Safety Evaluation to Support the Administrative
Change to St. Lucie Unit 2 DNB and LHR
Limiting Conditions for Operation (LCO's)

Statement of No Significant Hazards
Relating to the Administrative Change to
St. Lucie Unit 2 DNB and LHR Limiting Conditions
for Operation (LCO's)

Figure 3.2-2
AXIAL SHAPE INDEX vs fraction of maximum allowable power
level per Specification 4.2.1.3

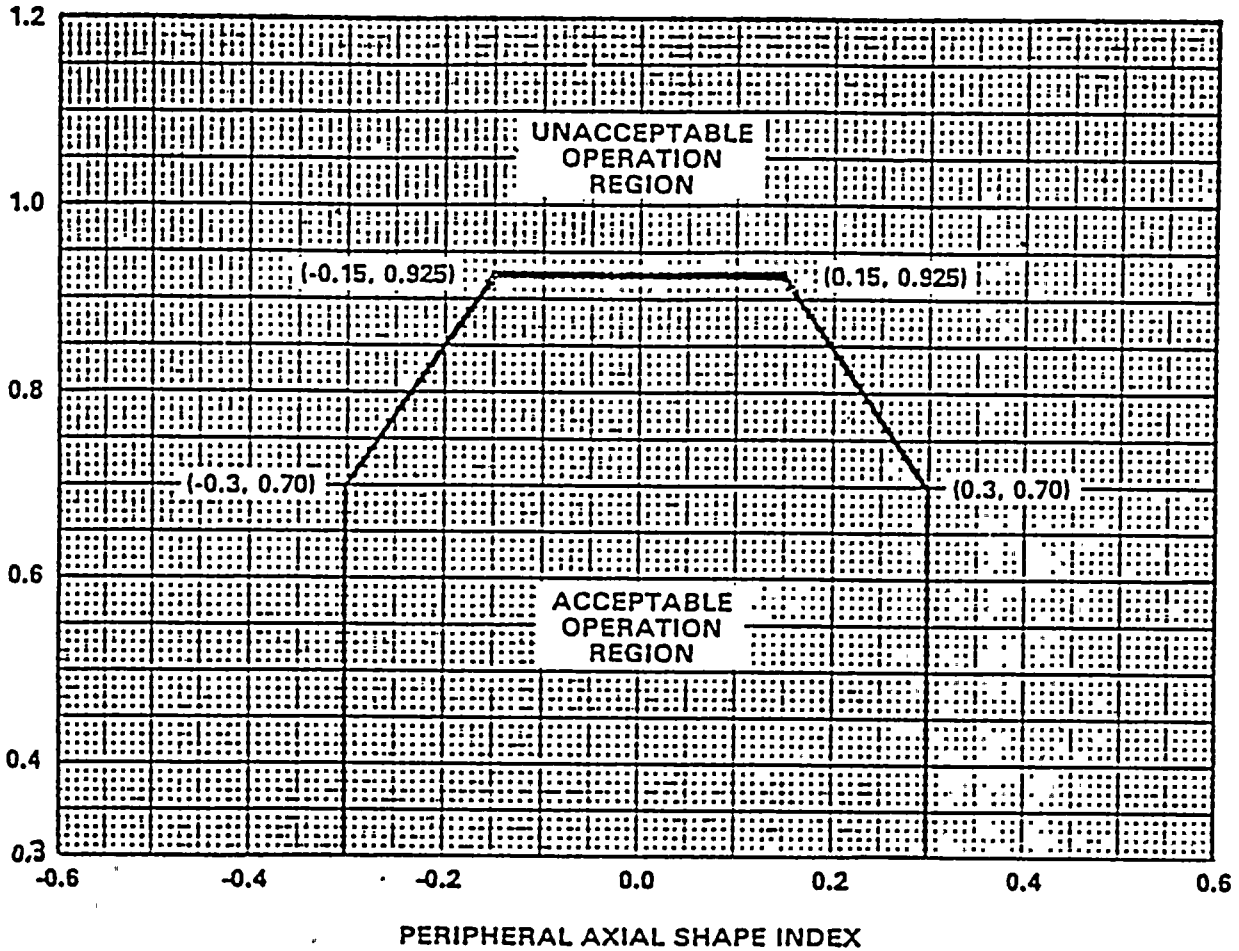
The purpose of the proposed change is to assure that the linear heat rate (LHR) and DNB LCO Figures 3.2-2 and 3.2-4 for St. Lucie Unit 2 correctly reflect the analytical basis used to generate them. Through an oversight, when these figures were drawn and included in the Technical Specifications, the y axis was not terminated at 30% core power. Below 30% power adequate protection is afforded by the Limiting Safety System Setpoints (LSSS).

The proposed amendment will redraw Figures 3.2-2 and 3.2-4 such that the y axis will terminate at 30% core power instead of at Hot Zero Power (HZP). Between 30% core power and HZP the curve for the LPD LSSS given in Figure 2.2-2 will bound plant operation and provide adequate assurance against violation of SAFDL's. No other aspects of the LCO Figures 3.2-2 and 3.2-4 are being changed as a part of this amendment.

than the presently defined LSSS's. To remove this ambiguity with respect to safety analysis and the Technical Specifications, below 30% power the axial offset permitted by the LSSS and LCO's will be defined to be equivalent for St. Lucie Unit 2.
